**Correspondence Between
Staff and Applicant
Approval Letter**

Re: 5-ZN-2016
Scottsdale Entrada

Below are SunChase's Responses to the Planning & Development Services Division's review of the above referenced development application submitted on 2/18/2016.

The Planning & Development Services Division has completed the review of the above referenced development application submitted on 2/18/2016. The following **1st Review Comments** represent the review performed by our team, and is intended to provide you with guidance for compliance with city codes, policies, and guidelines related to this application.

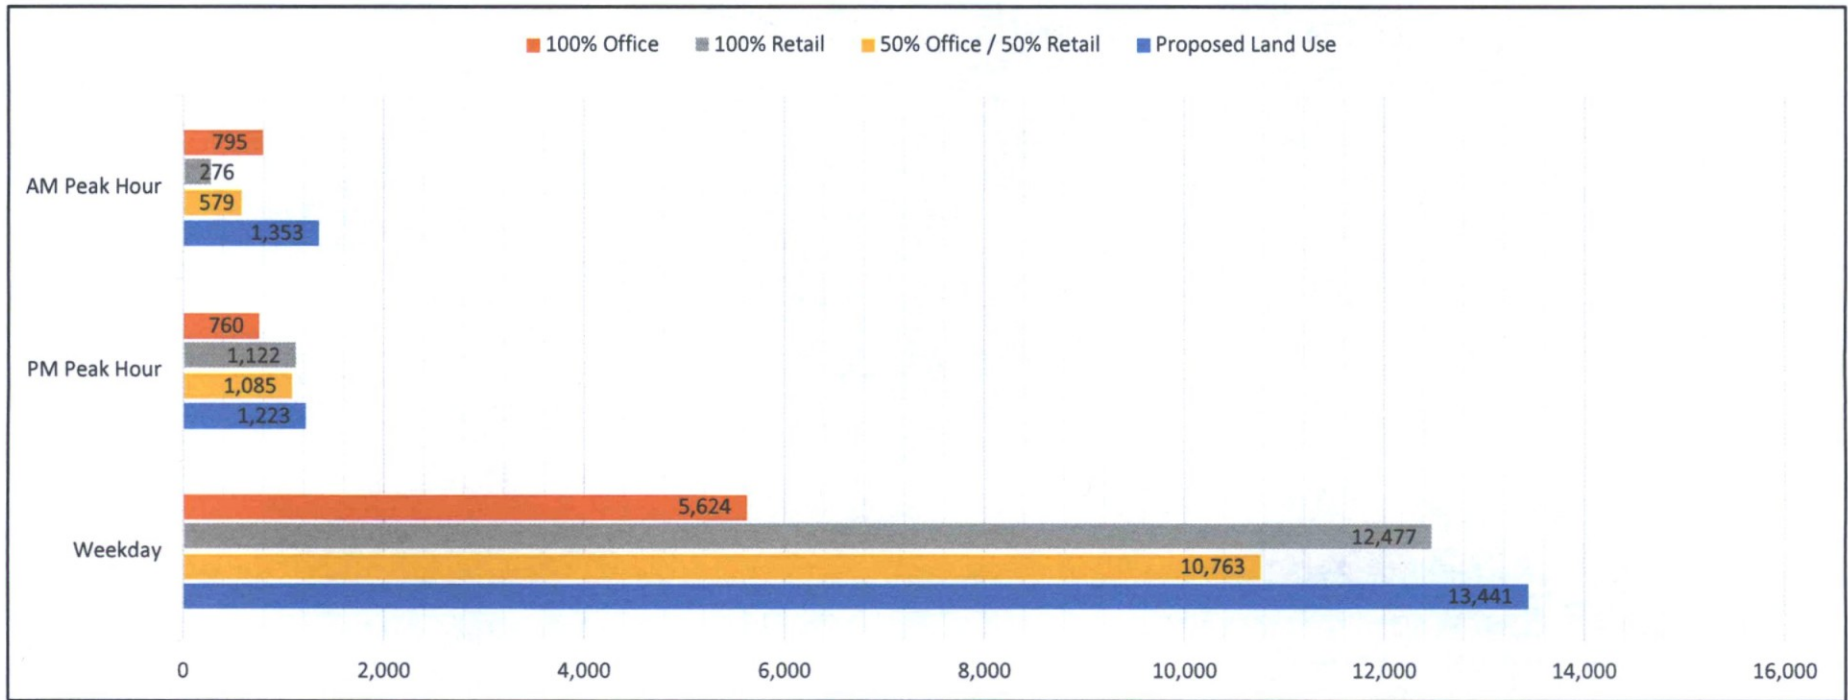
As a follow-up to our conversation a few minutes ago, below and attached are Burgess & Niple's (Randy Kill) trip generation comparisons (presuming office and retail FAR of 0.25) that estimate/compare ADTs and Peak Hour Trips for redevelopment of Sunchase's approximately 23 acre Site with:

- Red = 100% office; or
- Gray = 100% retail; or
- Golden = 50% office/50% retail; or
- Blue = Proposed PUD.

Based on our previous conversation I am sending you the requested trip comparison table. The trip generation used the following assumptions/process.
